**DfD-0021**

**Taran Laval – SAAA Builder 7417  
Van’s Aircraft RV7 - 73918**

## REVISED TANK FITTING METHOD

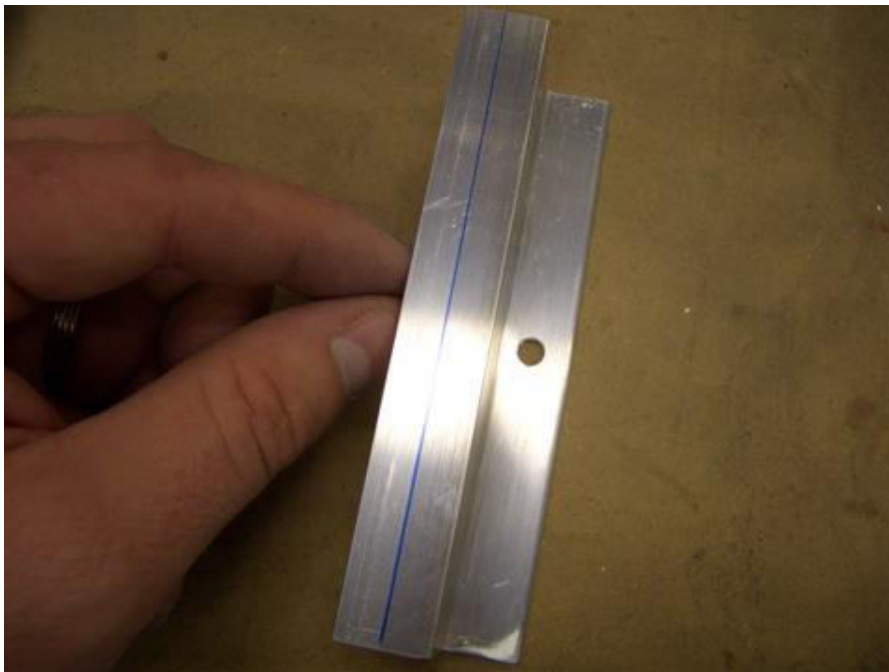
Next, drill a 3/16" (or #11) hole in each of the z-brackets. The root most bracket should have its hole shifted about 1/16" away from the web (relative to the center) to allow a wrench to be placed over these bolts.

The rest of the brackets should have the hole shifted about 1/16" toward the web. This will give a little more room on the other flange for the pop rivet tool to seat the pop rivets that hold these brackets onto the tank.

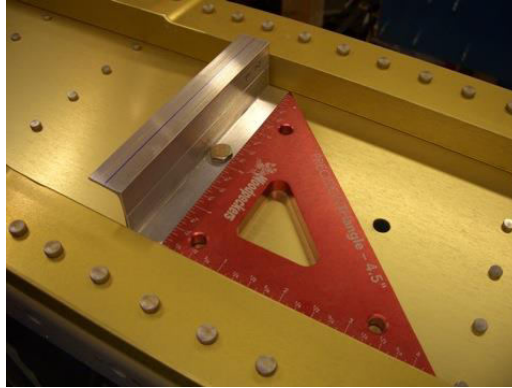
Using this center hole and some scrap bolts, tighten these brackets firmly to the spar (making sure to get the flange orientation correct).

After all brackets have been bolted to the spar, back drill them through the holes already in the spar.

Here is a closeup of what you should end up with.

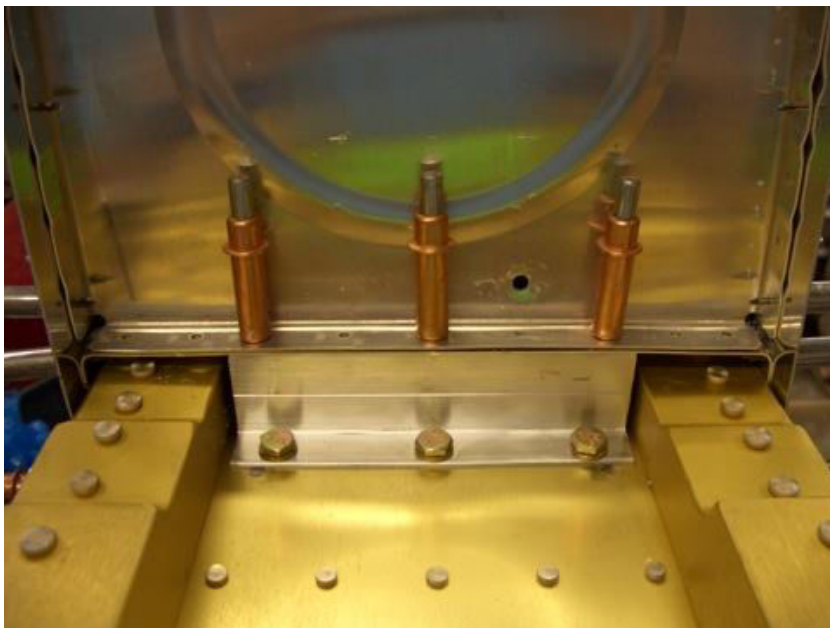
While the tank is in place, drill the tank to joint plate holes out to #19.

Now, drill the inboard z-bracket to the tank baffle and inboard rib. This is the only part of the baffle that can be reached right now.
